Addendum assessment and decision No.05 for proposed modifications to M1 Western Distributor Smart Motorway Project

Modification to the M1 Western Distributor Smart Motorway Review of Environment Factors (REF).

There are three (3) modifications proposed to the works scope of the M1 Western Distributor Smart Motorway (WDSM) Project that form the subjects of this memo.

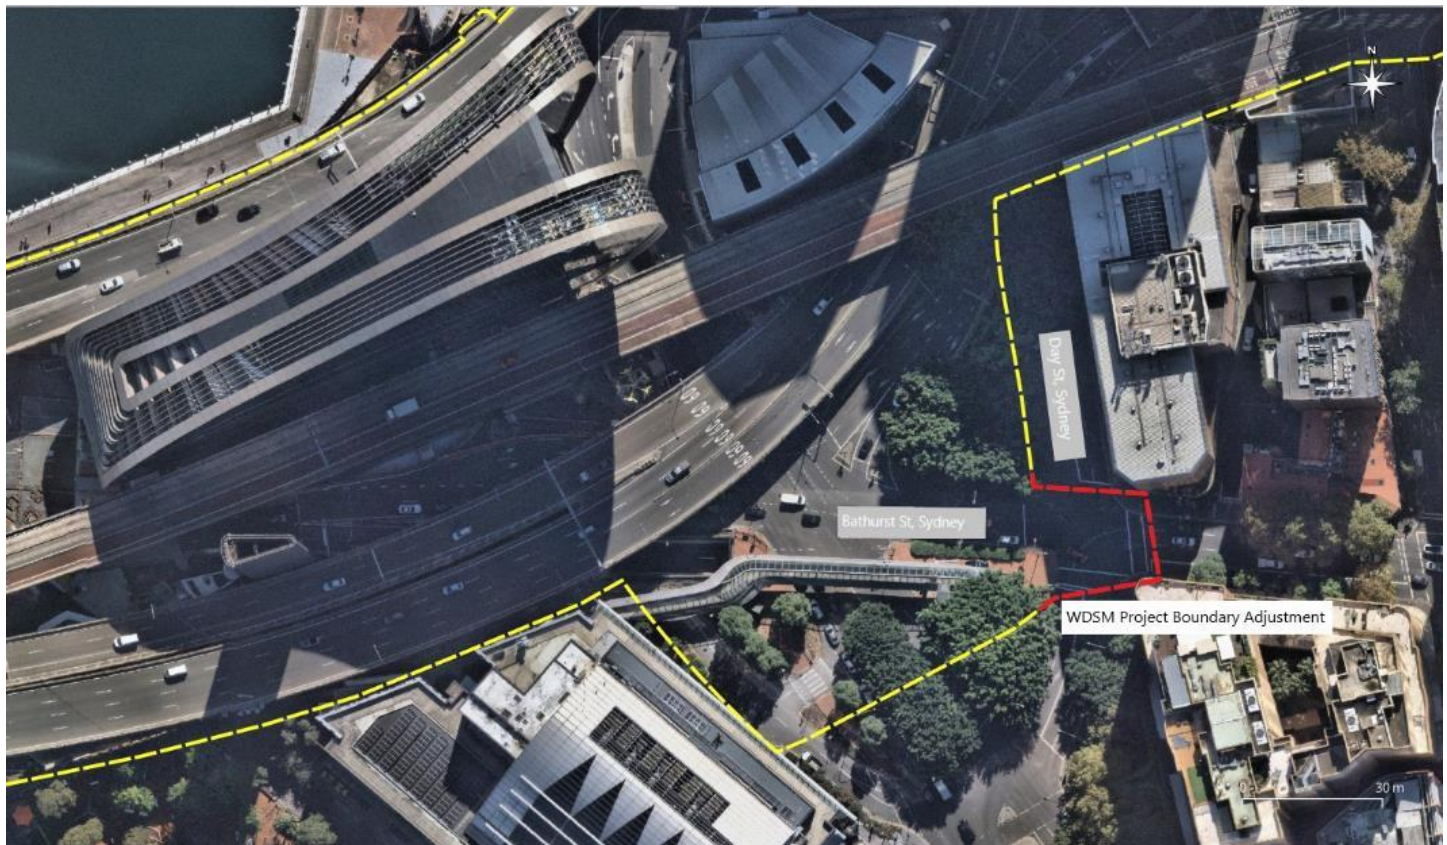
- The adjustment to boundary to increase the project area by an additional ~50 metres along the public road corridor, further to the east of the intersection of Bathurst Street and Day Street, Sydney. The proposed modification is shown in Figure 10, Figure 11, Figure 12, and Figure 13 of Appendix D.

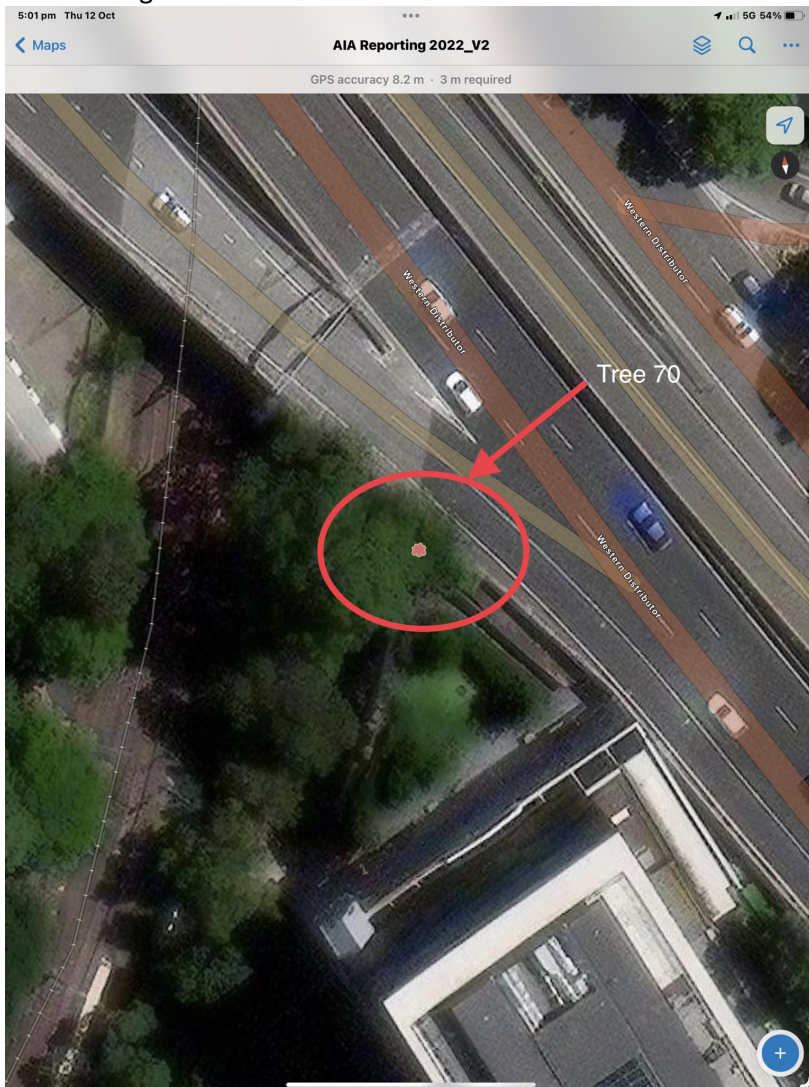
Please find attached the updated Tree register for the project from which I have deleted the trees that have been removed to date and added the additional trees at Pyrmont Bridge Rd & Bank St, Trees 6A, 6B & 8A. I have also added Tree 70 which is located adjacent to the off ramp to Pyrmont Bridge rd near the old Edwin Davey Flour Mill Building now called Harbour Mill as shown below.

As per our site meeting at the Harbour Mill building grounds on Monday 9th October 2023 I can confirm that the newly added T70 is an adventitiously germinated specimen of *Ficus microcarpa var hillii*. (Hills Weeping Fig) which is an exotic tree species in the young to semi-mature age category with a moderate amenity value and a low retention value.
